Access Compliance Report Public Rights-of-Way (Curb Ramps)

Main Street: GRAVIER_ST Cross Street: BOND_AVE Location: SW

ADA ID: RPRK211223111217 Ramp Type: Type 1 - Perpendicular Diagonal Initial Pass/Fail: Fail Overall Compliance: No Severity Score: 16

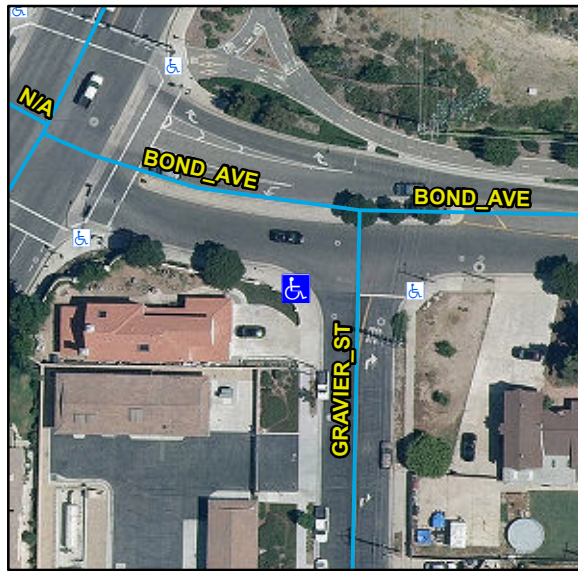
Compliance	Description	Data	Compliance	Description	Data
N/A	Ramp Length (in)	55	N/A	Flare Type LT	
Yes	Ramp Width (in)	48			N/A
No	Ramp Run Slope (%)	9	N/A	Flare Slope LT (%)	N/A
No	Ramp Cross Slope (%)	2.4	N/A	Flare Traversable LT	N/A
N/A	Landing Present	N/A	N/A	Flare Type RT	
N/A	Landing Length (in)	N/A			N/A
N/A	Landing Width (in)	N/A	N/A	Flare Slope RT (%)	N/A
N/A	Landing Run Slope (%)	N/A	N/A	Flare Traversable RT	N/A
N/A	Landing Cross Slope (%)	N/A	N/A	DWS Provided	N/A
N/A	Landing Movement Obstructed?	N/A	N/A	DWS Contrast	N/A
	Landing Movement Type	N/A	N/A	DWS Length (in)	N/A
N/A	Landing Shared	N/A	N/A	DWS Full Width	N/A
N/A	Clear Space	Yes	N/A	DWS Offset Left (in)	N/A
N/A	Clear Space To Crosswalk (in)	N/A	N/A	DWS Offset Right (in)	N/A
N/A	Marked Crosswalk 1	No	N/A	Marked Crosswalk 2	No
	Crossing 1 Direction	E		Crossing 2 Direction	N
	Marked Crosswalk 1 Width (in)	N/A		Marked Crosswalk 2 Width (in)	N/A

N/A	Ramp Inside Crosswalk 1	N/A	Yes	Ramp Inside Crosswalk 2	N/A
	Crossing 1 Slope (%)	4.8		Crossing 2 Slope (%)	2.6
	Crossing 1 Cross Slope (%)	3.3		Crossing 2 Cross Slope (%)	4.2
N/A	Gutter Ponding	N/A	N/A	Curb Slope	2
Yes	Gutter Lip Height (in)	0		Road Run Slope (%)	2.6
N/A	Gutter Run Slope (%)	N/A		Road Cross Slope (%)	4
N/A	Gutter Cross Slope (%)	N/A			
Yes	Overall Surface Condition: Acceptable		Yes	Perp Joint Present	Yes
	Cross Gutter Present?	No		Spandrel Present?	No
	Replace Cross Gutter?	N/A		Replace Spandrel?	N/A

Remove & Replace Curb Ramp With Two New Directional Ramps or Equivalent.
